## **Byron Environmental Audit – Request for Additional Information Response**

**Question #: HCR-1**

**Category: Historical and Cultural Resources**

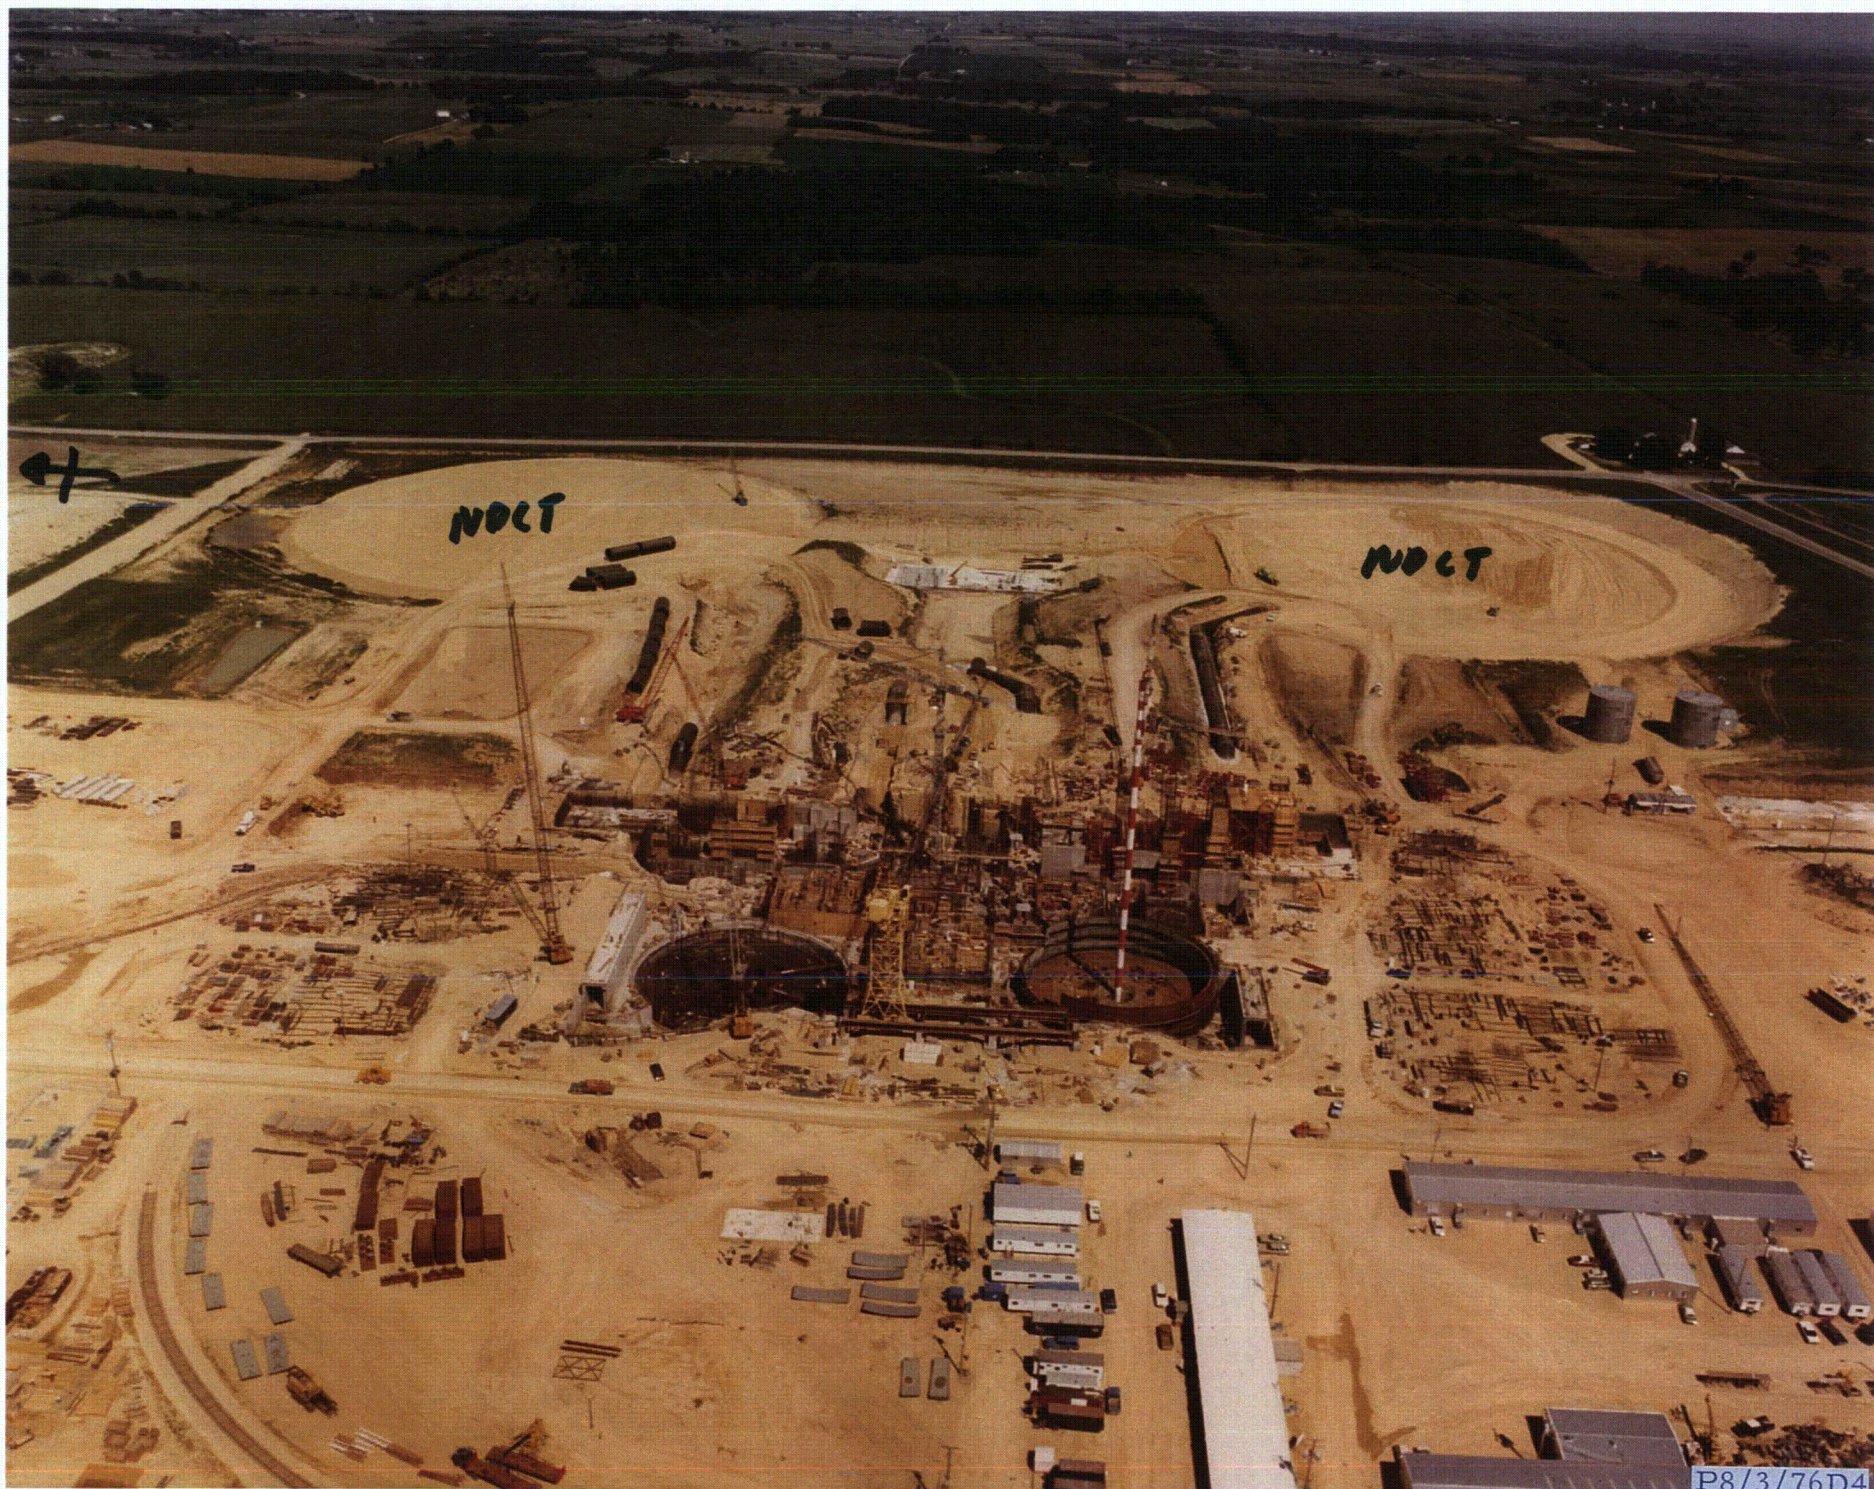
Provide a series of aerial photographs of the entire plant site and associated transmission line(s) (during pre-construction, construction, and post-construction periods) looking at levels of disturbance that occurred during construction or since operation, whether any historic structures or possible sites are present on the property, and identifying any recent projects that will require a review of additional documentation.

Aerial photographs of the plant site during the pre-construction and construction time frames are attached to this response. Also, in a letter dated February 1974, the Illinois SHPO stated that no cultural or historical sites of significance were located within the Byron project boundaries. A copy of the 1974 letter from the Illinois SHPO to the U.S. Atomic Energy Commission is attached to this response.

Byron UFSAR (Exelon Nuclear 2010a), Figure 8.2-3

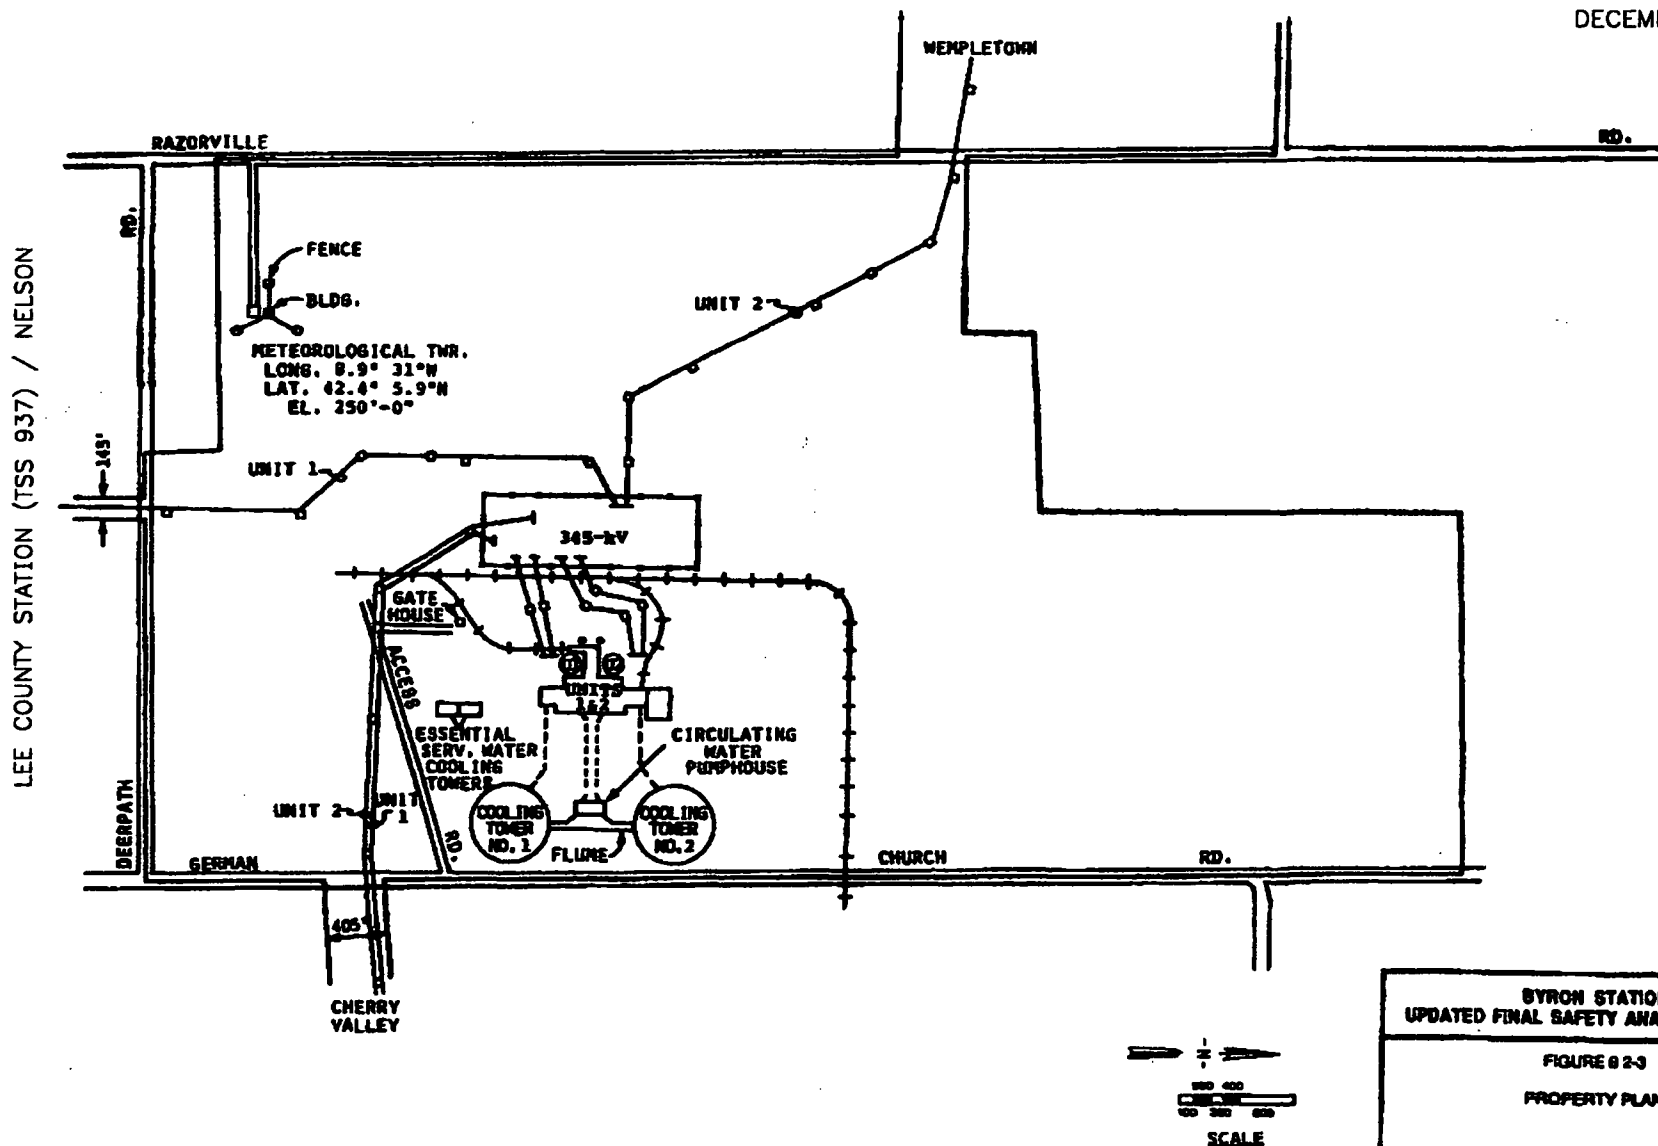
Provide a description of ComEd's transmission line management plan, including: timing of activities, danger tree removal and other clearing, inspections and repair activities conducted by ground vehicles, standard operating procedures or guidelines for the applicant and any contractors; erosion control procedures, technician training programs, and any regulations that restrict maintenance activities (e.g., looking for activities that could affect depth of disturbance, if any disturbance is necessary along the corridor).

Because the NRC will now apply the new regulations to define the scope of transmission lines for which environmental impacts are analyzed in the License Renewal Supplemental Environmental Impact Statement for Byron Station, Exelon Generation has revisited its original evaluation of the in-scope lines. Electricity generated at Byron Station is transformed from generator voltage to a nominal 345-kV transmission system voltage by the main power transformers. The main power transformers are connected via intermediate, on-site transmission lines to the on-site 345-kV Byron Station

switchyard. The location of the intermediate transmission towers on the site property is shown in Byron UFSAR (Exelon Nuclear 2010a), Figure 8.2-3. For ease of reference, a copy of the figure is attached to this response. Based on this information and that there are no other transmission lines that would be dismantled or otherwise decommissioned as a result of terminating operations at Byron, Exelon concludes that, under the new regulations, the intermediate, on-site transmission lines are the only in-scope transmission lines for the Byron license renewal environmental review. These transmission lines are located entirely within the station's protected area. Grounds management practices for that area are described in the Request for Additional Information Response HCR-7.
